AERONAUTICAL CHARTING MEETING
Charting Group
Meeting 23-01 – April 25-27, 2023

RECOMMENDATION DOCUMENT

FAA Control #24-01-389

Subject: Removal of Taxiways on Instrument Approach (IAP) Chart Airport Sketches

Here is an example of the ORD airport sketch with and without taxiways, aprons, and hardstands:

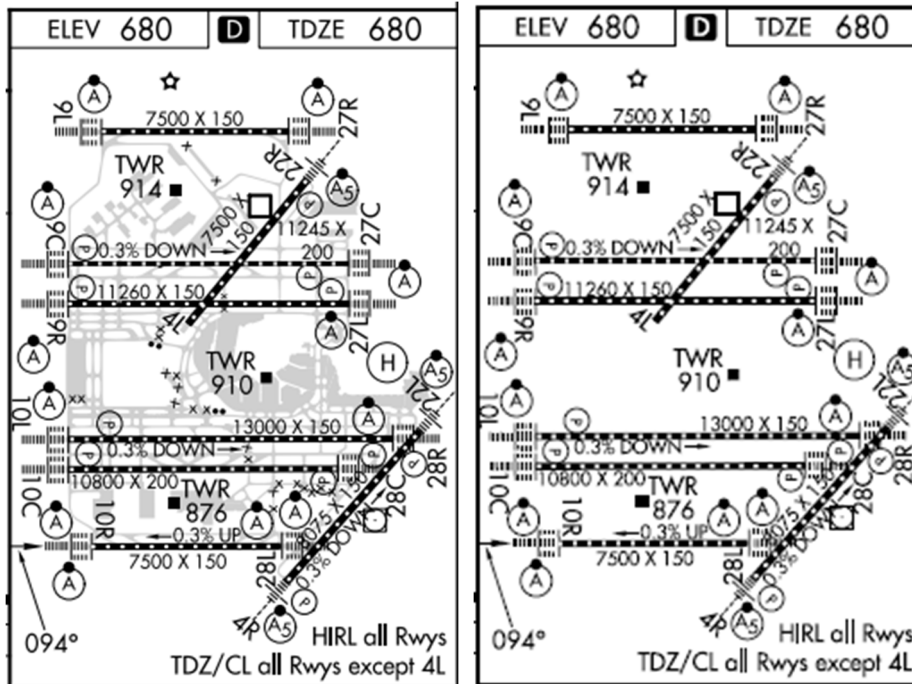
simplification of the airport sketch, including the removal of taxiways, aprons, and hardstands.
